June 28, 2016

**RE: RESPONSE TO LETTER REGARDING ECOLOGY COMMENTS AND
CORRECTIONS ON FARALLON MEETING SUMMARY
LAKEVIEW FACILITY
2800 104TH STREET COURT SOUTH, LAKEWOOD, WASHINGTON
FARALLON PN: 188-002
VCP IDENTIFICATION NO: SW1012**

FIGURE 4

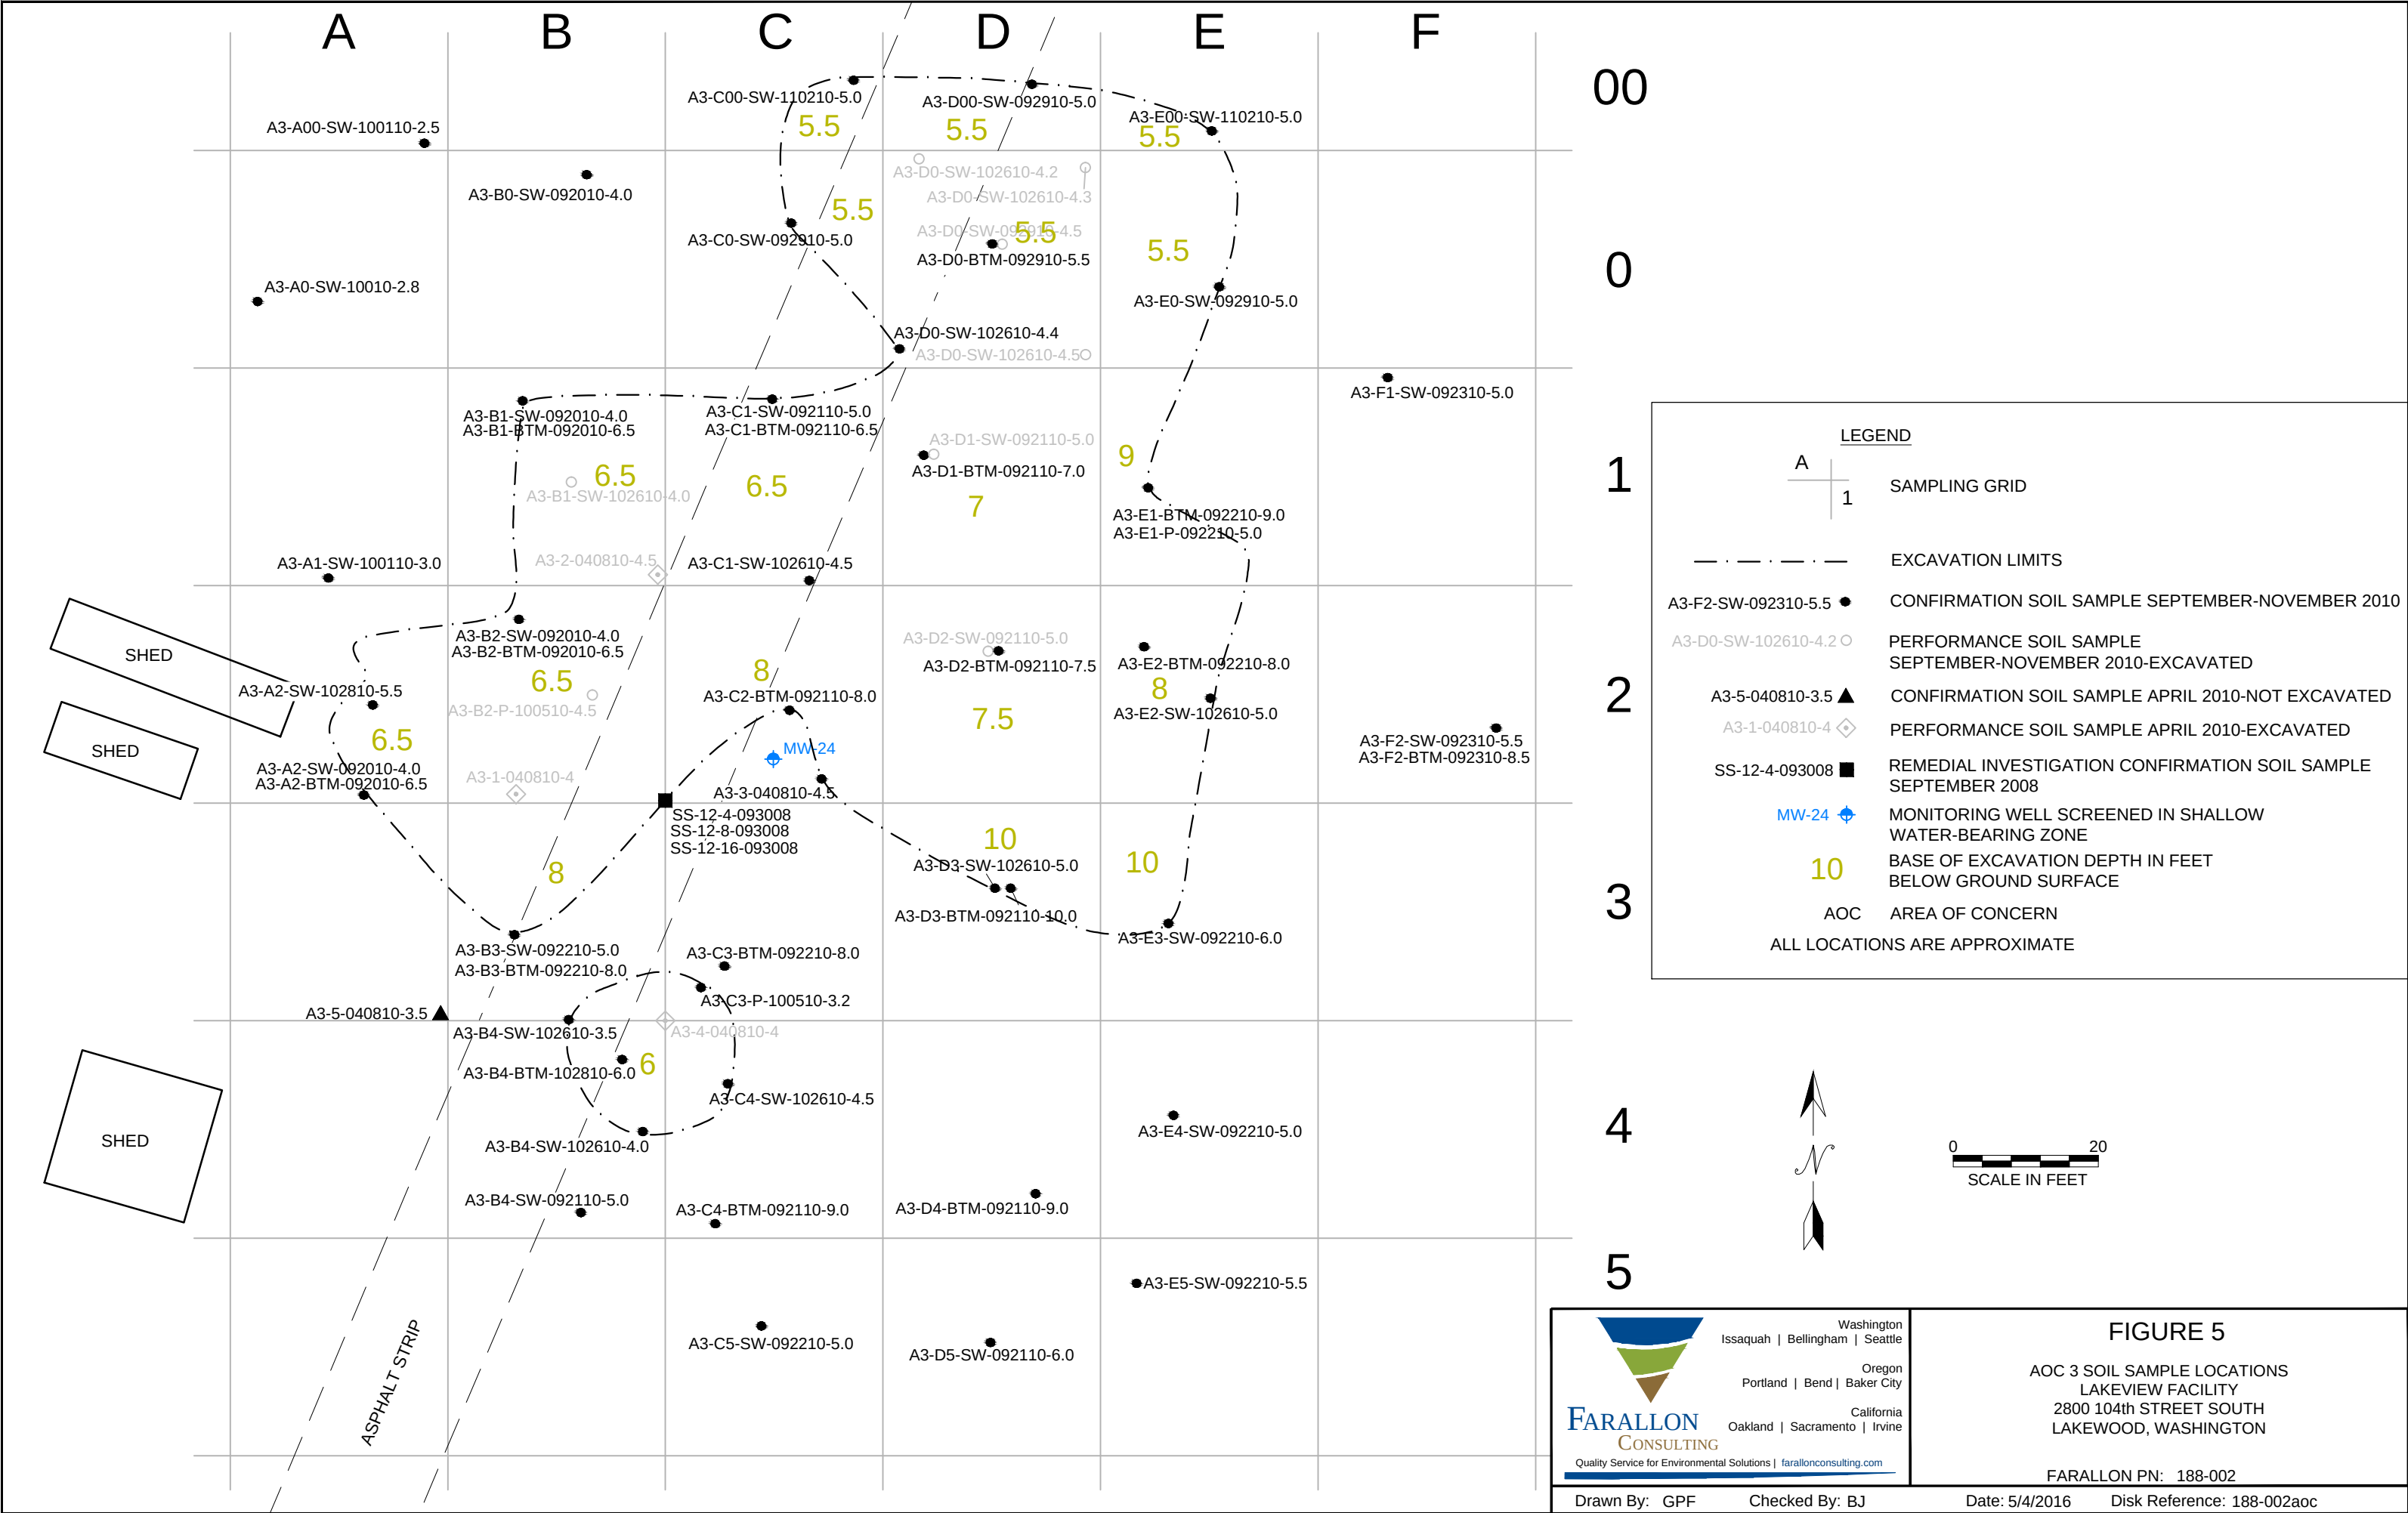
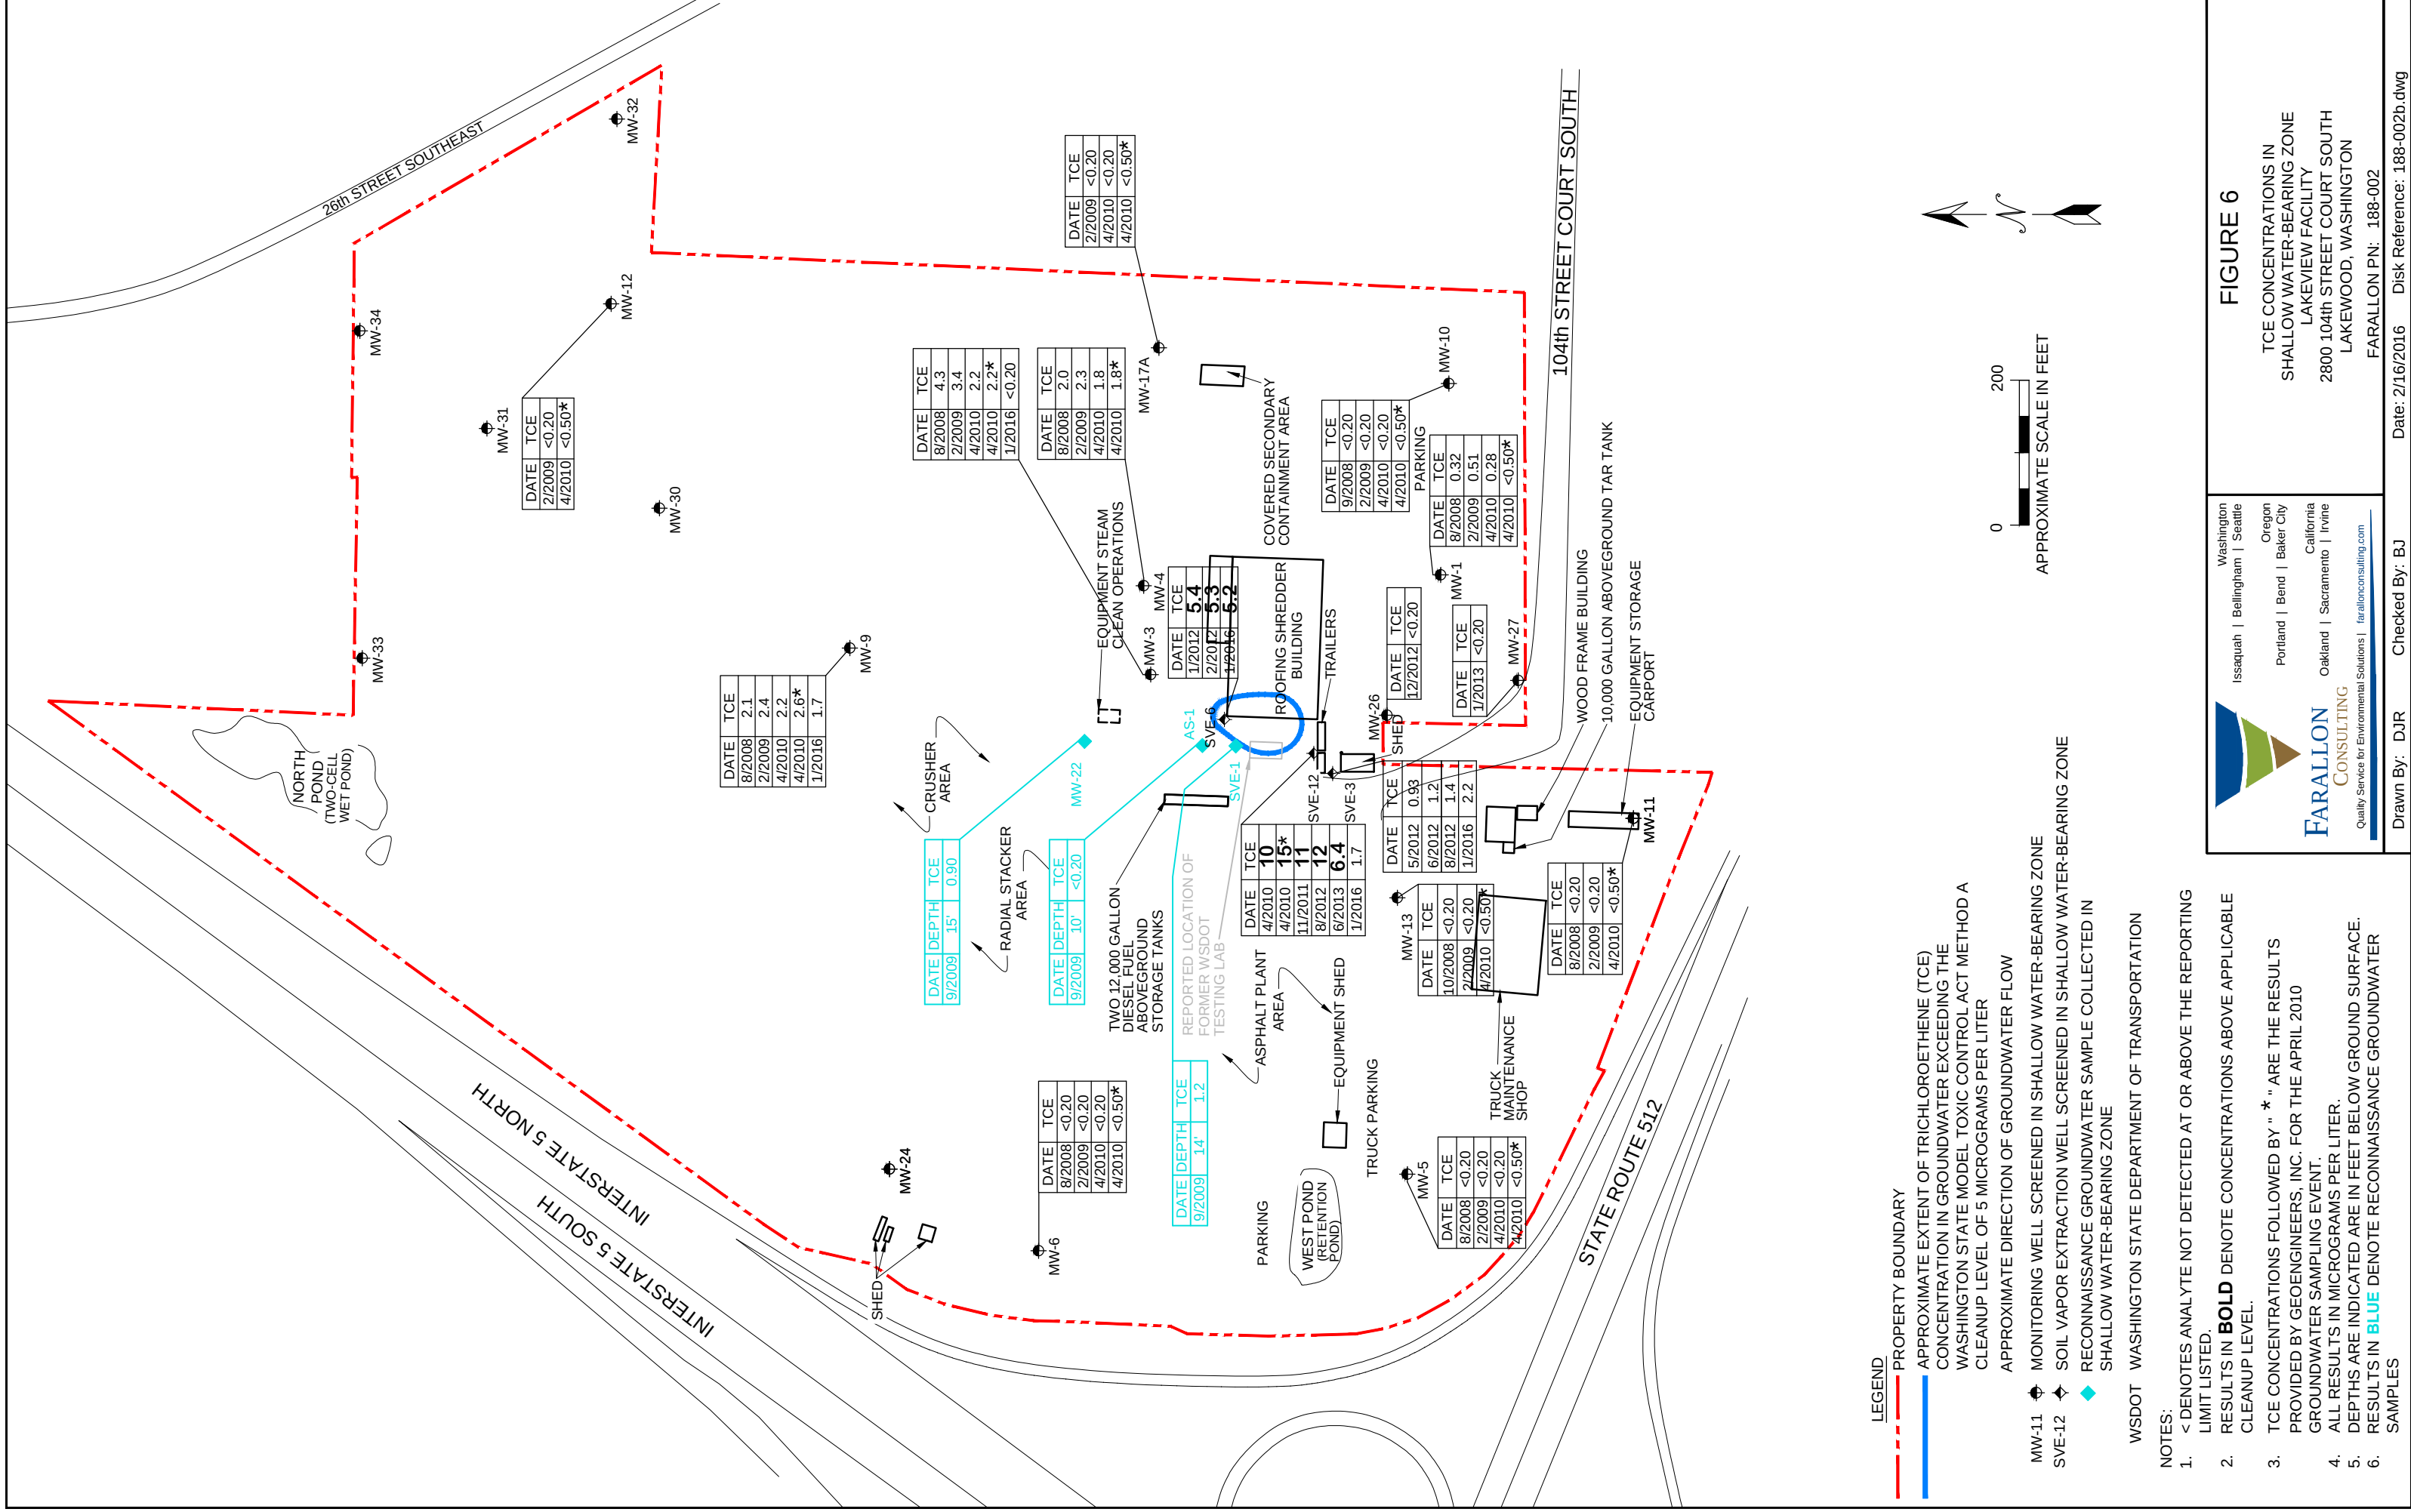
Ecology Comment: *Figure 3 from the 2011 Soil Excavation Cleanup Action Report, the figure was unclear when depicting the excavation bottom. The narrative was also not clear as to the bottom depth across the excavation at specific locations. The reader is left to wonder if all the contaminated soil was excavated. Did the bottom vary in depth to coincide with the soil contamination? Some of the soil confirmation data points were questionable because of the widespread distance from (clean and dirty) sample locations, as providing supportable evidence that the contamination had been removed. Photos of the excavations would provide clarity to the how the excavation was completed.*

Farallon Response: The bottom depth of each of the three excavations was described in the text of the Soil Excavation Report. In addition, the figures depicted the identification and depth of collection for each soil sample. Revised Figures 3, 4, and 5 in this letter more clearly identify the depth of excavation in each 30- by 30-foot grid area for AOCs 1, 2, and 3.
